RESOLUTION HOLDING HEARING ON REQUEST FROM HUBBELL REALTY COMPANY TO REZONE PROPERTY LOCATED AT 3422 BEAVER AVENUE AND TO APPROVE THE "EDENCREST IN BEAVERDALE" PUD CONCEPTUAL PLAN

Communication from the City Plan and Zoning Commission advising that at their meeting held October 15, 2015, the following action was taken regarding a request from Hubbell Realty Company (developer) represented by Steve Niebuhr (officer) to rezone property located at 3422 Beaver Avenue.

CONCEPTUAL PLAN EDENCREST IN BEAVERDALE

EDENCREST IN BEAVERDALE
PLANNED UNIT DEVELOPMENT

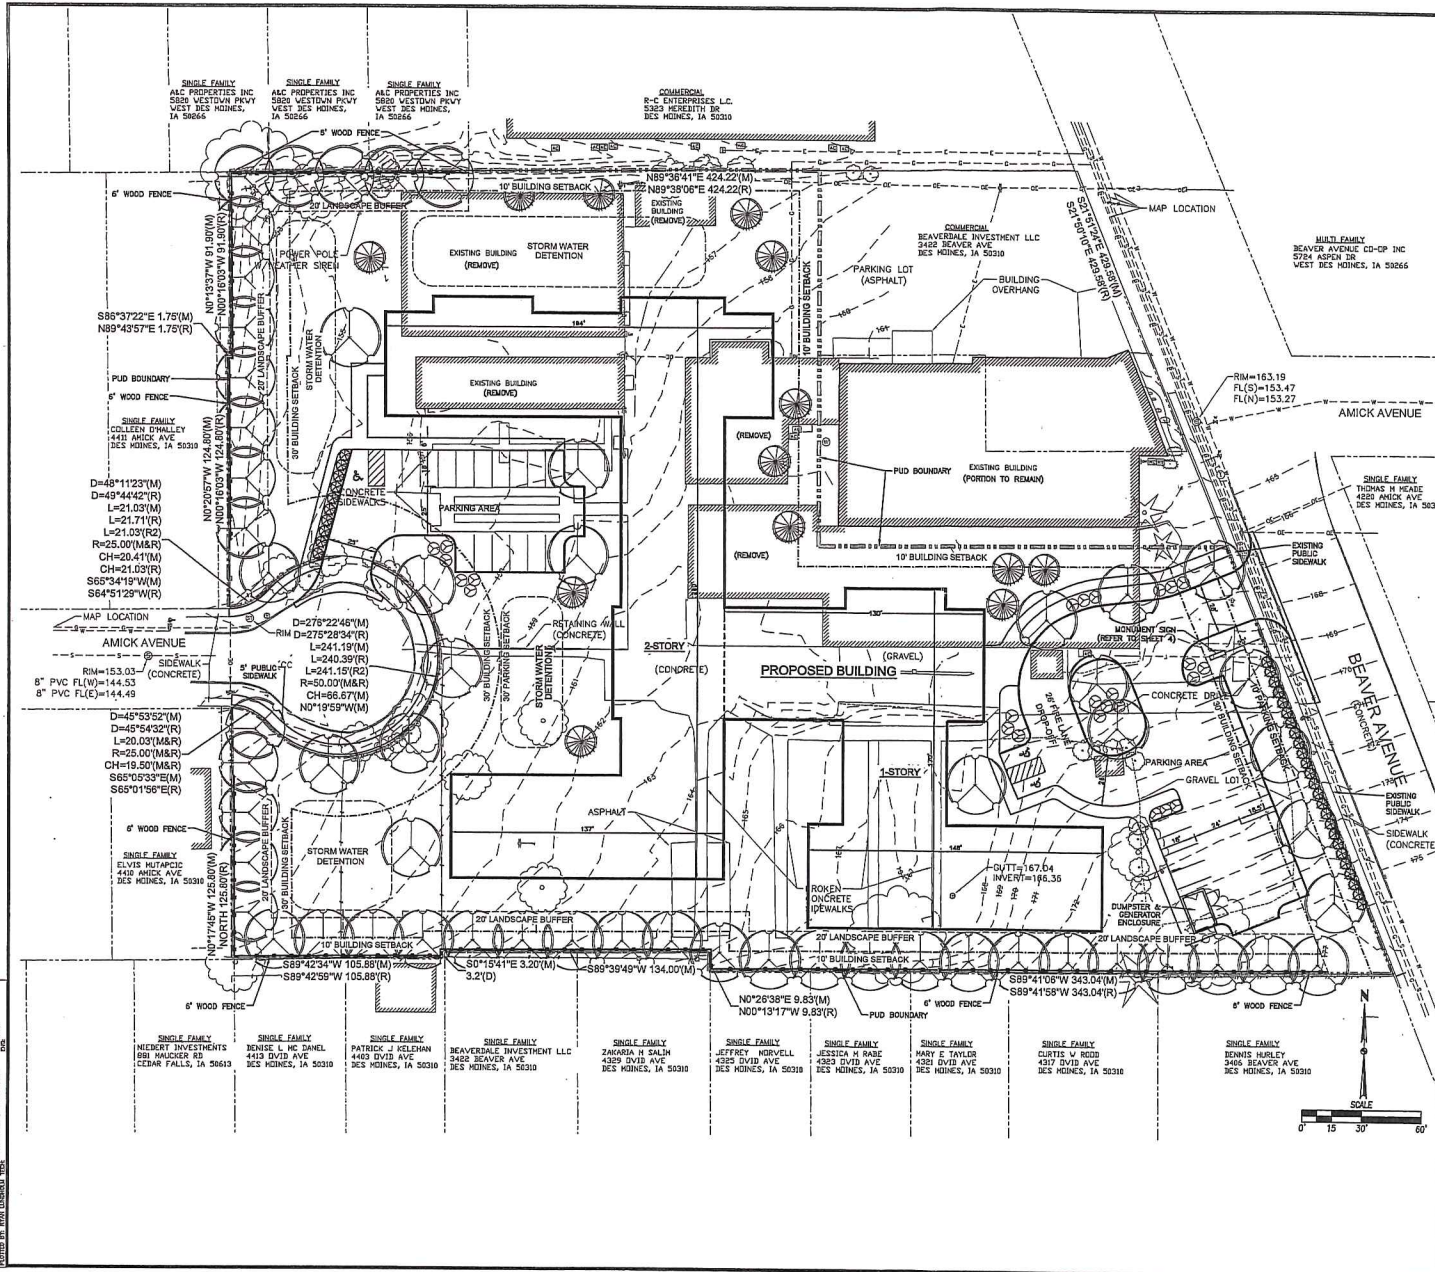
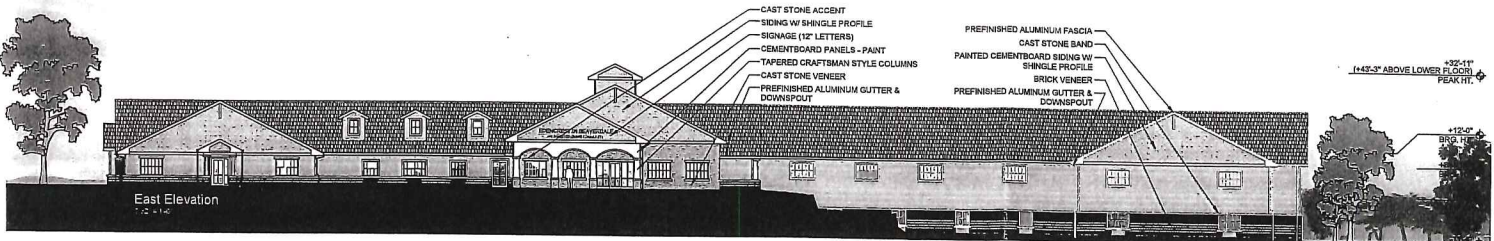
3. The PUD Conceptual Plan needs to contain additional details regarding the service connections to all public utilities.
4. The PUD Conceptual Plan shall demonstrate conceptually that the buffer yard plantings (two overstory trees and six evergreen trees per 100 lineal feet) will be provided. Only overstory trees are shown.

5. The PUD Conceptual Plan shall be revised to reflect a street tree every 30 lineal feet along both the Beaver Avenue and Amick Avenue frontage.
6. The developer shall provide a street lighting design for the Beaver Avenue frontage that complies with the City's street lighting standards.

The Conceptual Plan shows plantings throughout the site that generally address these requirements except that there are not any evergreen trees conceptually shown within the bufferyard areas. The number, placement and species will be fully evaluated at the development plan stage. Staff recommends that street trees be provided along all street right-of-ways space at one per 30 feet. This would soften the views of the development from the adjoining residential development in addition to providing the typical aesthetic and environmental benefits association with street trees. Along Beaver Avenue this would include species which may be planted below overhead utilities.

Steve Neibuhr stated yes and also the new plan shows relocation of the trash enclosure as requested, saving the tree, changing the buffering to get all of the evergreen. It incorporated much of the site plan comments. It also shows where the utilities are coming from.

Edencrest in Beavertdale
PUD Conceptual Building Exterior Designs & Signage

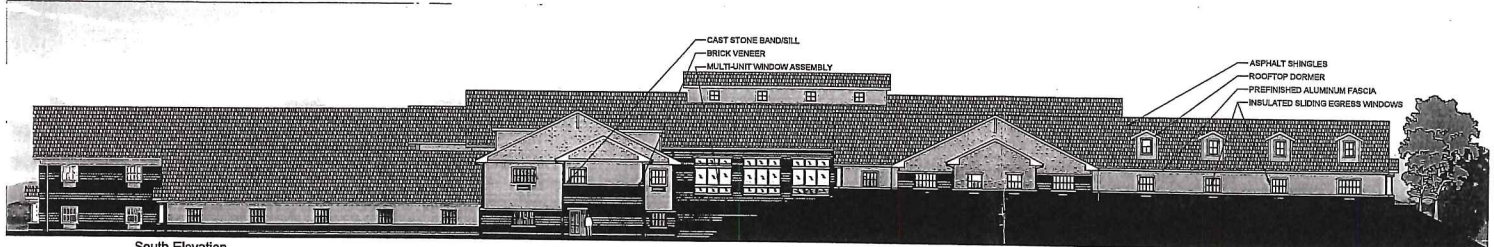
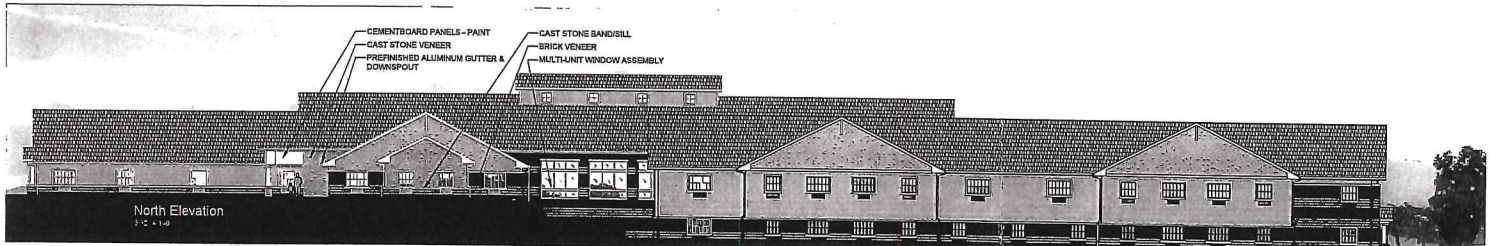
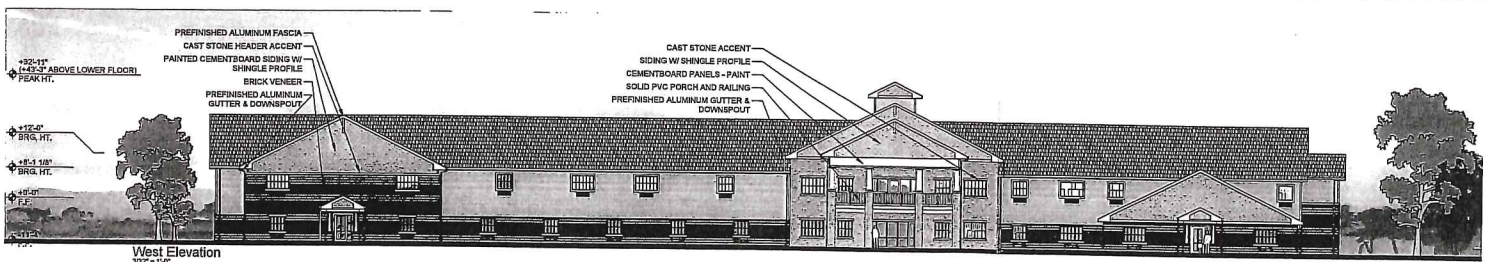
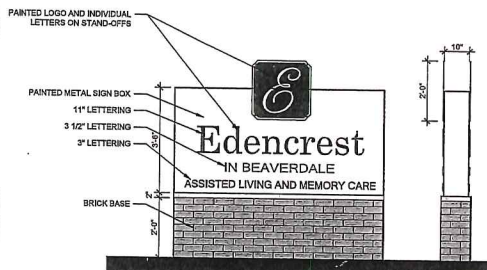
8. The building elevations for the structure shall be revised in accordance with the following and subject to approval by the Planning Administrator:
 - a) At least two-thirds of the surface area of building façades facing Beaver Avenue or Amick Avenue, shall be sided with brick or stone. At least one-third of the building façades facing the side yards shall be sided with brick or stone.

- b) A note shall be added to state that any trim shall consist of cement board material.
 - c) Gables on the structure shall include exposed rafters, decorative beams or braces, and/or shake-style cement board siding.

- d) A note shall be added to state that all windows on the structure shall be double-hung with a multi-light over single pane "craftsman" style.
 - e) A note shall be added to state that all exterior entry doors on the structure shall have multi-light "craftsman" style windows.

- f) A note shall be added to state that all windows and exterior entry doors on the structure shall have trim surrounds of at least 4 inches in width.

- g) A note shall be added to state that the roof will have architectural-type asphalt shingles with a minimum 30-year warranty.

- h) A note shall be added to state that any HVAC equipment shall vent through the roof and rooftop vents shall be complimentary in color to the roofing material. Any rooftop mechanical equipment shall be not be mounted on the Beaver Avenue side of the building and shall be architecturally screened from view.

- i) A note shall be added to state that all utility meters, transformers, ground-mounted equipment, and other utilities shall be placed on building facades that face away from the public streets.

The proposed PUD Conceptual Plan provides elevations that demonstrate the 2-story building would primarily be clad with horizontal overlap and shake cement-board siding, with brick materials on lower portions of the façades and stone material near the primary entrances. In order to be compatible with the character of the surrounding area, staff recommends that the elevations be revised so that at least two-thirds of the surface

Staff also recommends that additional design details be provided to demonstrate that the building will be compatible with the character of the Beavertdale area. Gables on the structure should include exposed rafters, decorative beams or braces, and/or shake-style cement board siding (which has been proposed). All windows on the structure should be double-hung with a multi-light over single pane "craftsman" style and all exterior entry doors on the structure should have multi-light "craftsman" style windows. This is generally being proposed. Staff also recommends that a note be added to state that all windows and exterior entry doors on the structure will have trim surrounds of at least 4 inches in width.

Monument Sign Elevation
12' x 14'

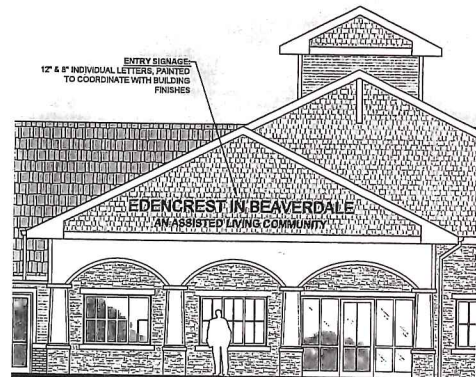
9. The note on the PUD Conceptual Plan sign requirements regarding monument signs must be clarified to state that any freestanding signage will be monument-style with bases constructed of brick or stone materials that match the masonry materials used on the primary structure.

5. **Signage:** The proposed PUD Conceptual Plan indicates that the development will have a monument sign and would allow "R-3" District sign requirements. The total height of the monument sign is 8 feet and is intended to match the character of the development and would be constructed with materials to match the development. It is proposed to be setback 20 feet from Beaver Avenue. Staff recommends that the note be clarified to state that any freestanding signage will be monument-style with bases constructed of brick materials that match the brick or stone materials used on the primary structure.

Sasha Kamper stated according to the plan that the Commissioners have in their packet the sign measures out to be 5' 8" and not 4'.

Steve Neibuhr stated the plans in their packet is not correct. There is a new plan submitted to staff late so the Commissioners do not have it in their packet. The new plan shows a sign that just under 4'.
